**HARBOR FREEWAY  
TRANSITWAY  
EXTENSION**

# **Milestone 2 – Major Investment Study**

**December 11, 1996**

**HARBOR FWY TRANSITWAY EXTENSION MAJOR INVESTMENT STUDY**  
**Figure No. 2.1**  
**NO BUILD ALTERNATIVE**

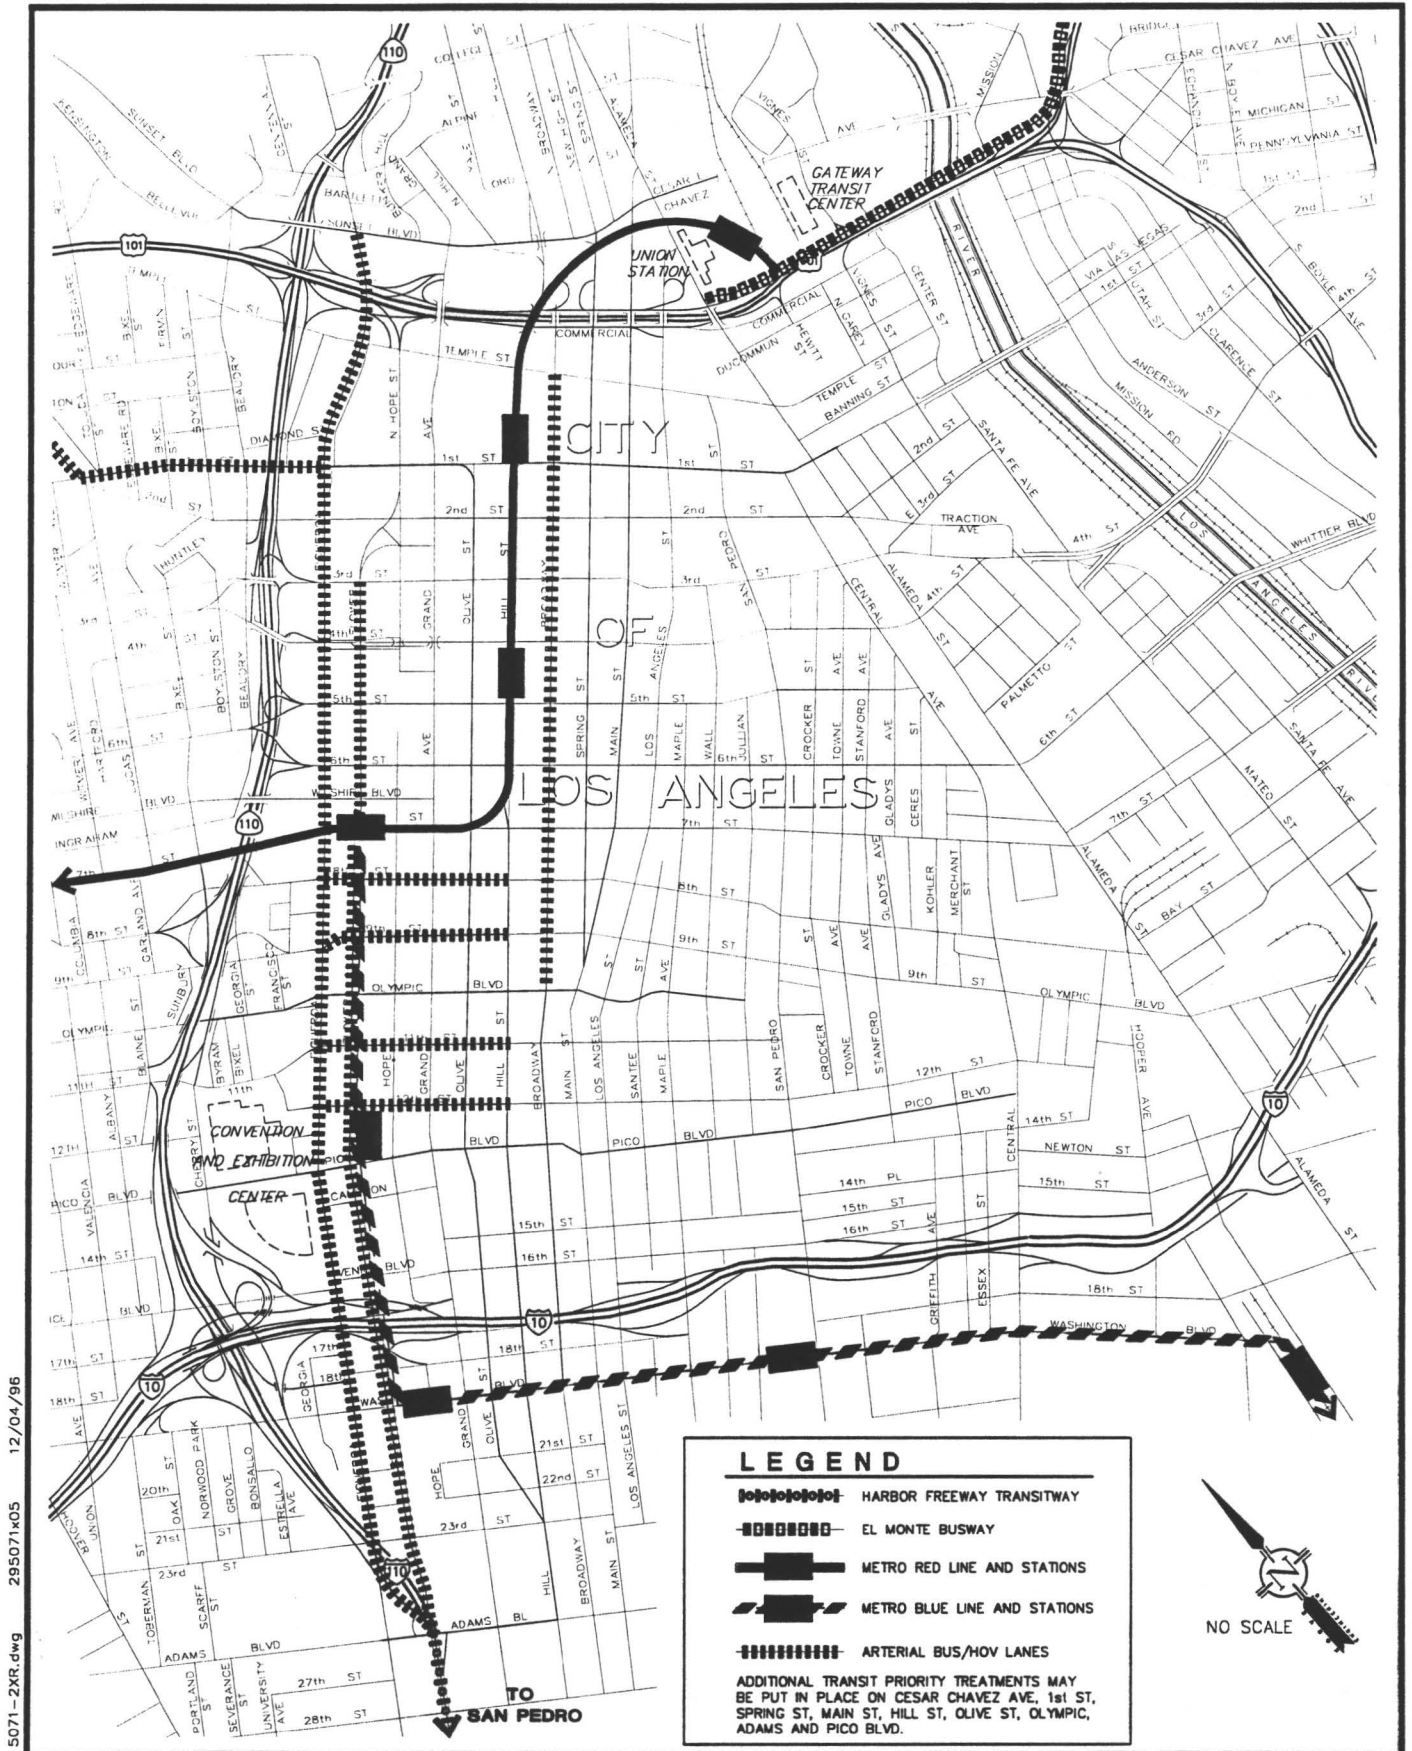
- b) Par. 3 - Figure 2.1 shows many arterial bus/HOV lanes and priority improvements that are not programmed.

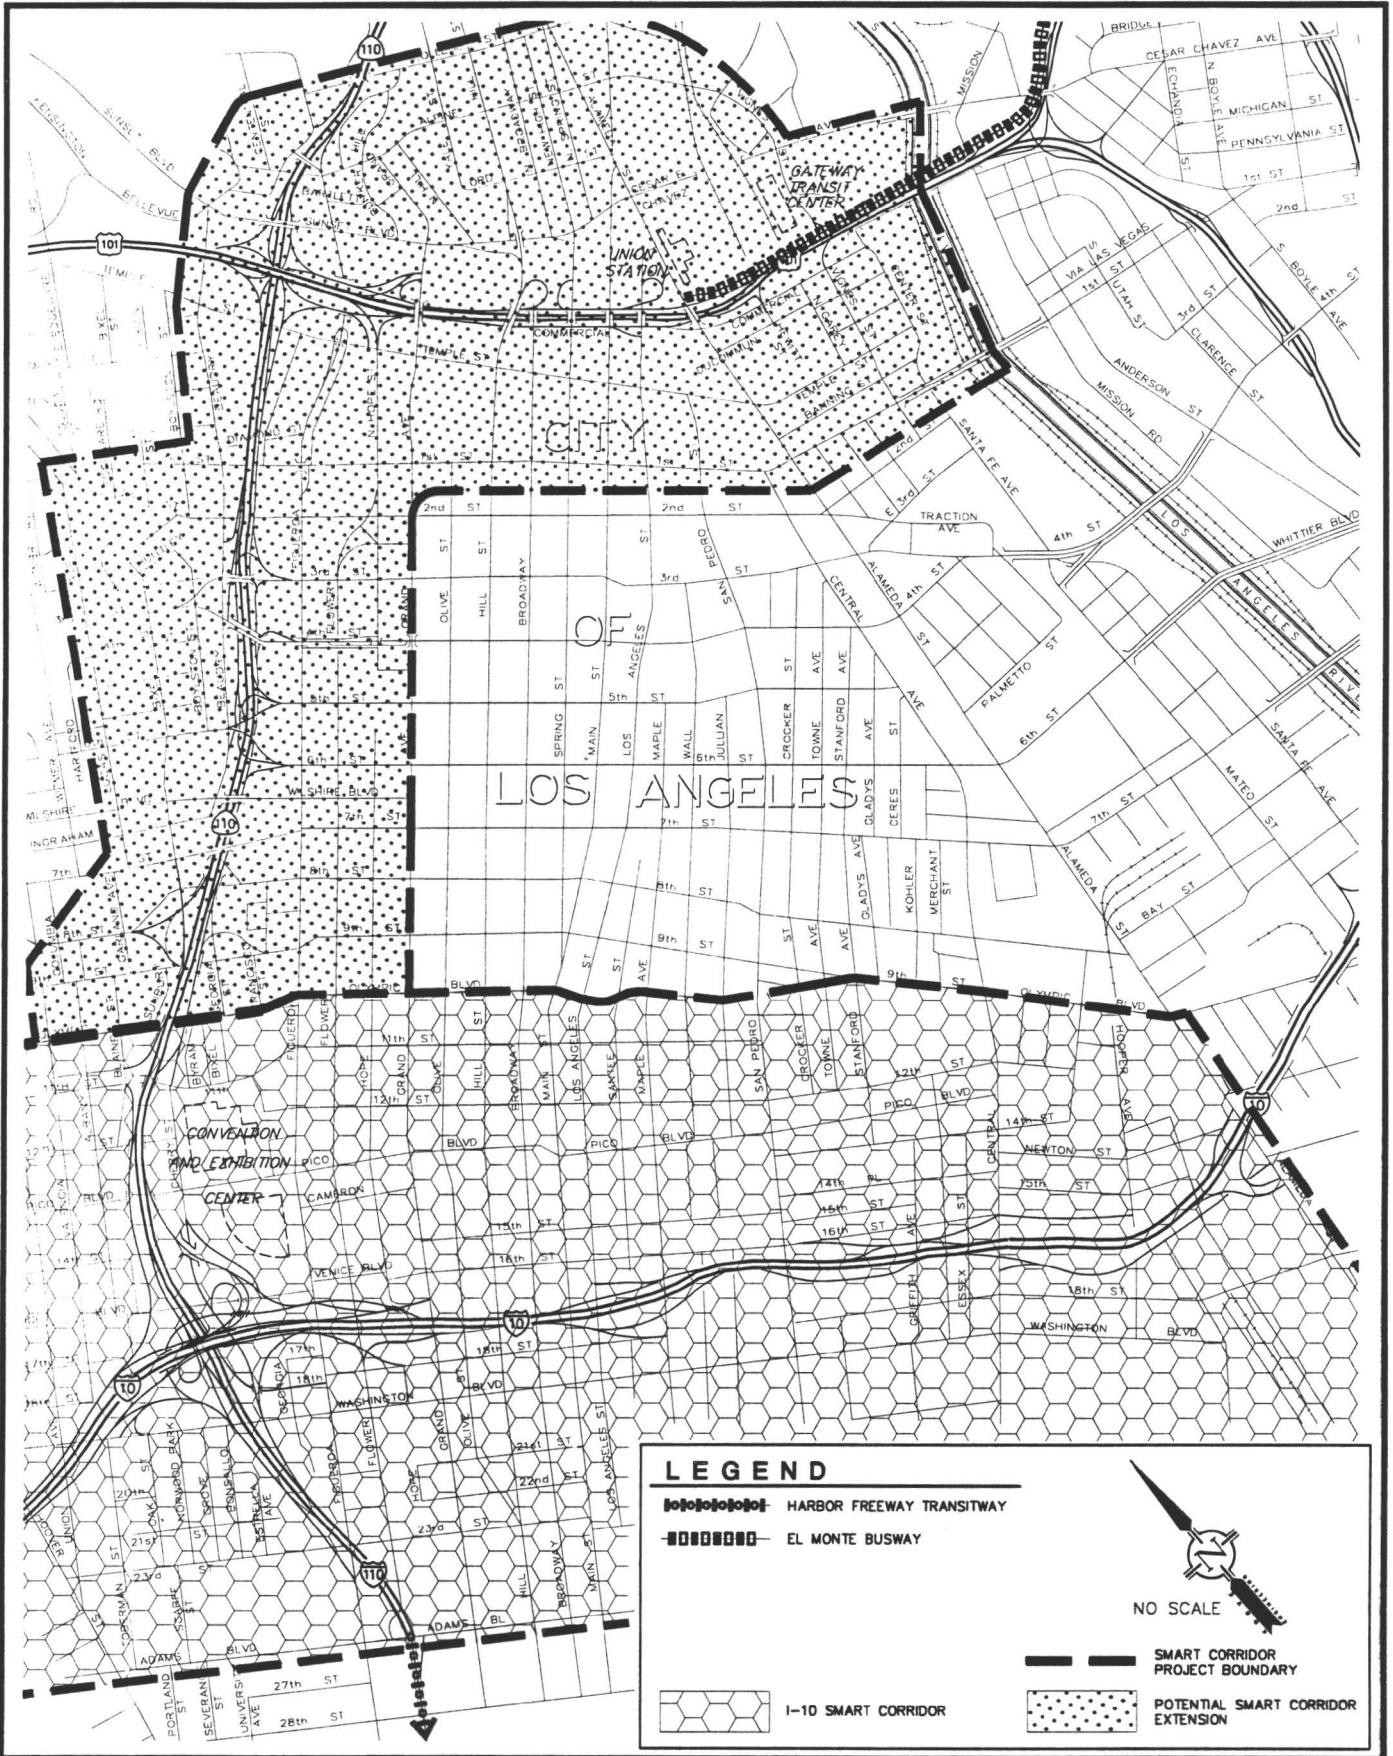
We are not in favor of TSM Transportation System Management or the No-Build alternative as shown on p. 14 and Map Figure 2.2.

**HARBOR FWY TRANSITWAY EXTENSION MAJOR INVESTMENT STUDY**  
**Figure No. 2.5**  
**BUS/HOV LANE ALTERNATIVE ( EXTEND IN FREEWAY RIGHT-OF-WAY )**

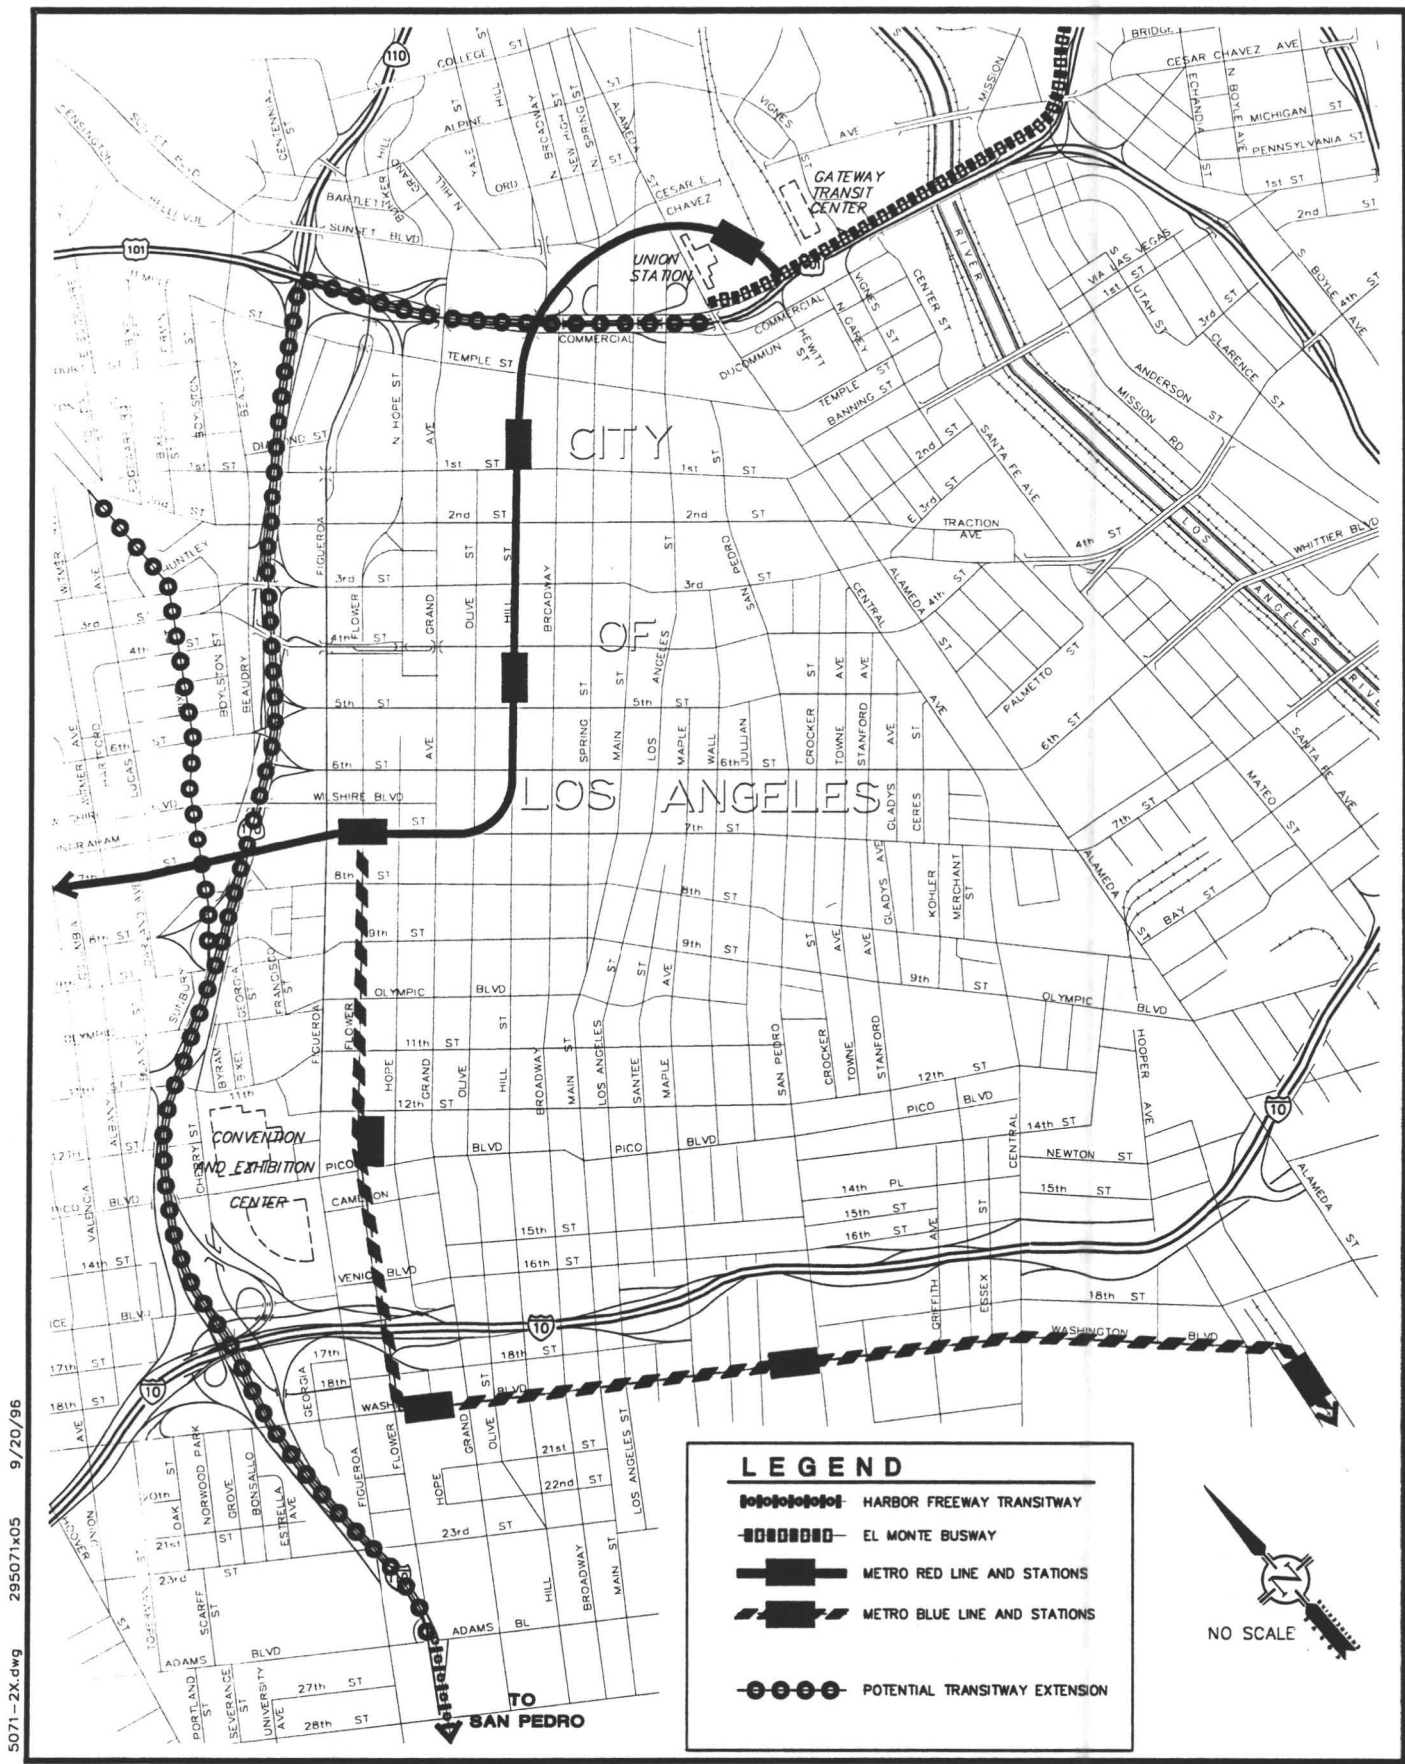
12. Page 22
- a) **Figure 2.5 - Show Stations.**
13. Page 25
- Par. 2 - Comment: **must prepare a study concerning the connectivity to the El Monte Busway.**

**HARBOR FWY TRANSITWAY EXTENSION MAJOR INVESTMENT STUDY  
 LIGHT RAIL TRANSIT ALTERNATIVE Figure No. 2.10  
 ( COLISEUM EXTENSION AND DOWNTOWN CONNECTOR )**

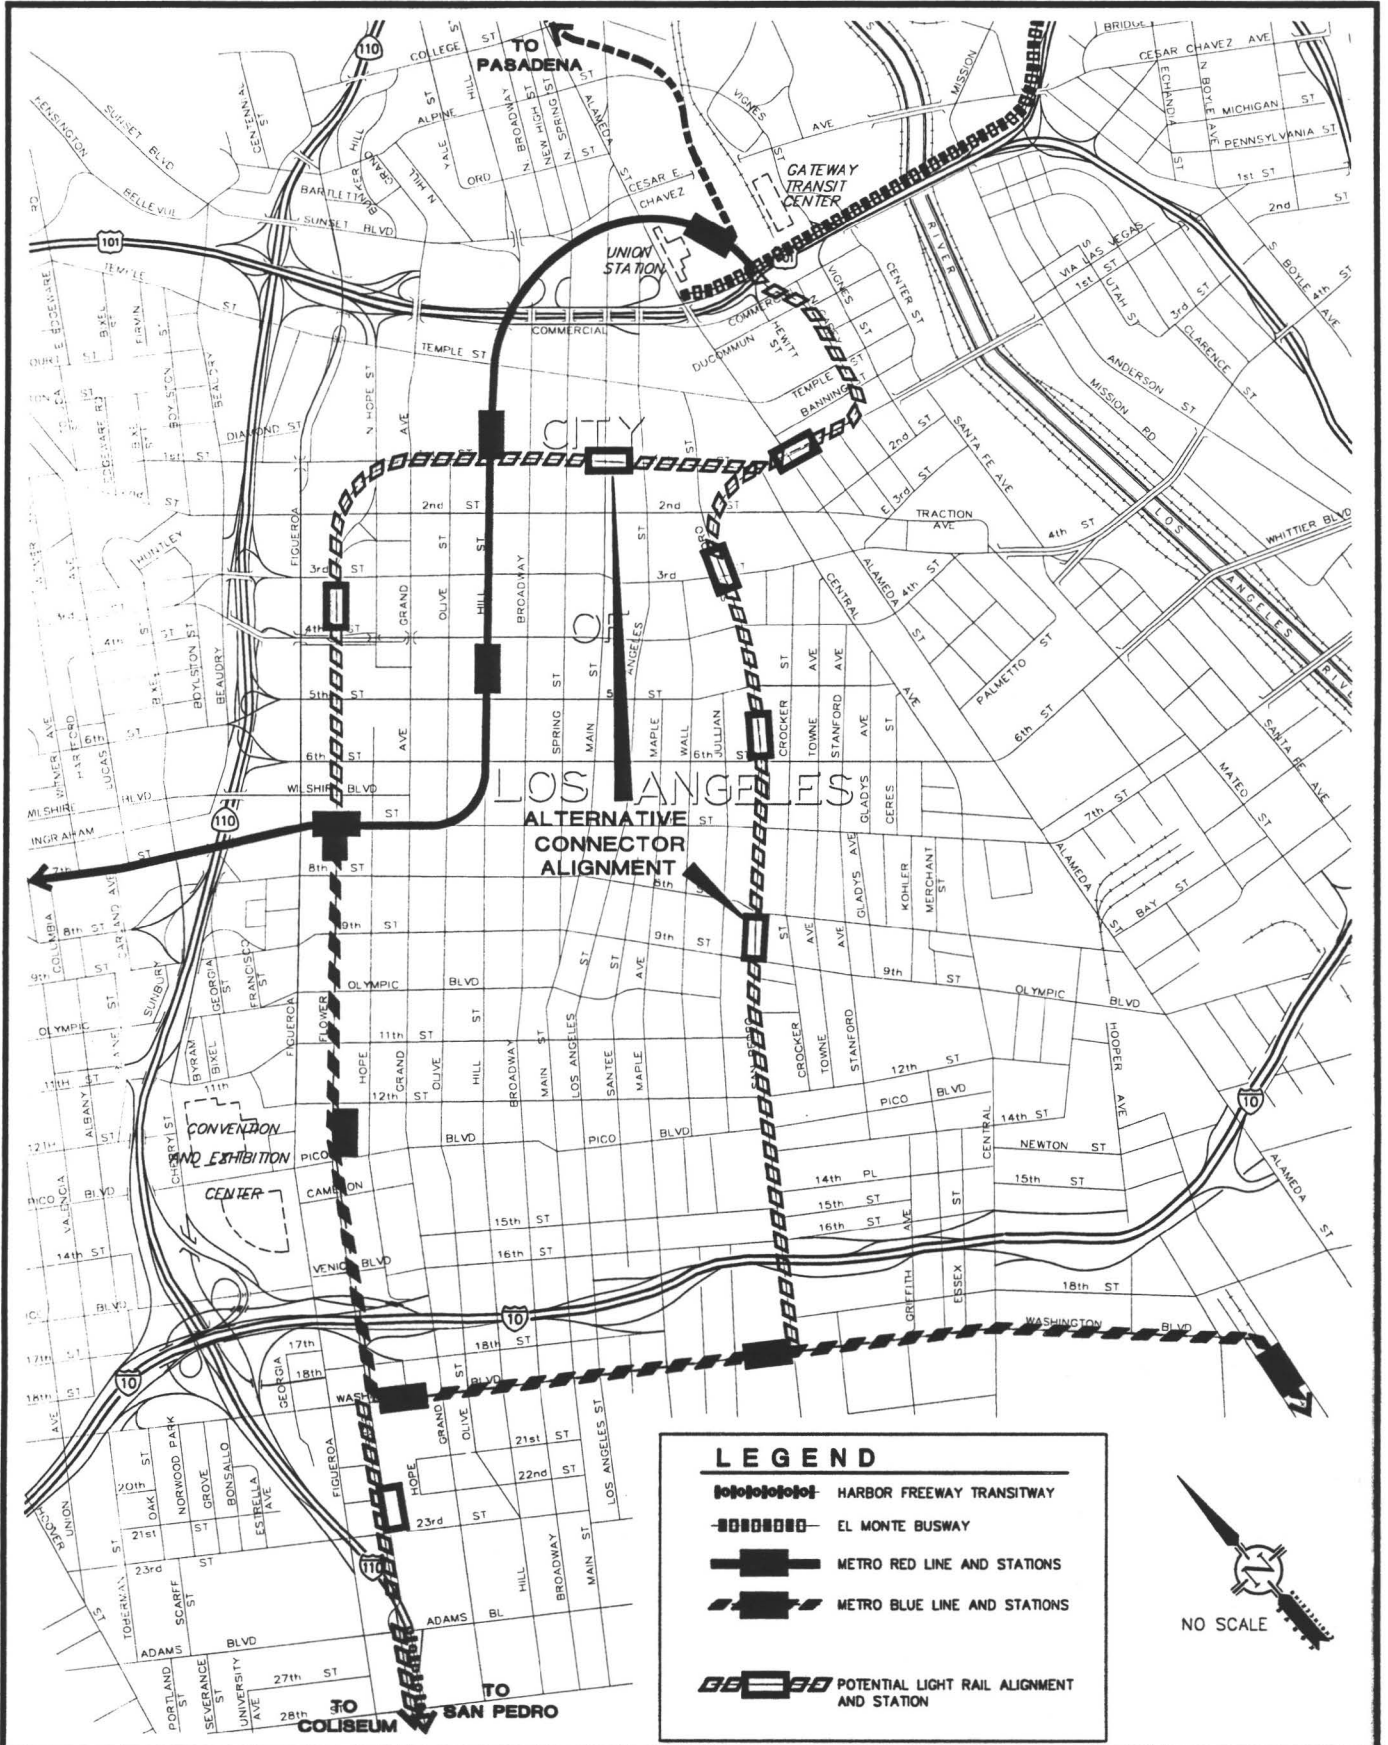
We liked another alternative shown on p.30, Light Rail Transit-Blue Line Extension and Downtown Connector as the map (figure 2.10) indicates that this would not affect El Pueblo at all.
